INITIAL FIRE SAFETY INSPECTION REPORT

TM Jeans Ltd

RSC ID: 25935

Date: 12-Nov-2024

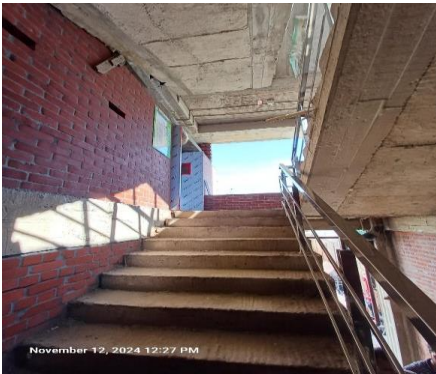
F-6	Means of egress	Guards height of 2 feet were found on the 1st floor in the Building-2 (Medical, Childcare & Dining Building) which is not as per standard.	Guards shall be provided with a minimum height of 1067 mm (42 in). Open guards shall have intermediate rails or pattern such that a sphere 200 mm (8 in.) in diameter cannot pass through any opening up to a height of 865 mm (34 in.).	Within 1 Month

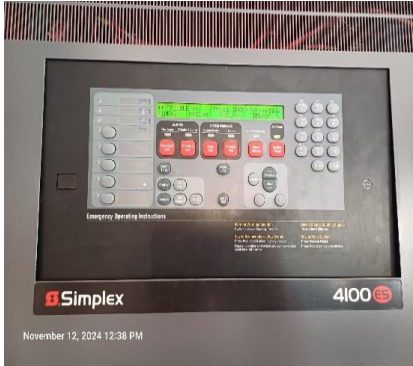
F-11	Means of egress	Building did not have stair designation signs, floor designation signs and occupant load signs at required locations on all floors. (Building-2 (Medical, Childcare & Dining Building))	Provide stair designation signs, floor designation signs and occupant load signs at required locations.	Within 1 Month

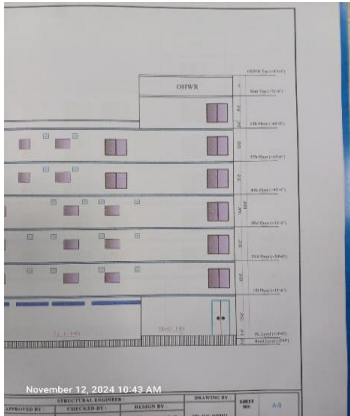
F-13	Emergency Lighting	Based on the number and location of emergency lights observed, adequate illumination levels are not anticipated along egress routes and at exit stairs on all floors. (Building 1 (Production Building), Building-2 (Medical, Childcare & Dining Building))	Test the emergency lighting system on each floor and provide additional emergency fixtures to supply adequate illumination along the means of egress. Provide a minimum illumination of 10 lux at the floor level within exit stairs and along exit discharge paths and a minimum 2.5 lux along exit access aisles.	Within 2 Months
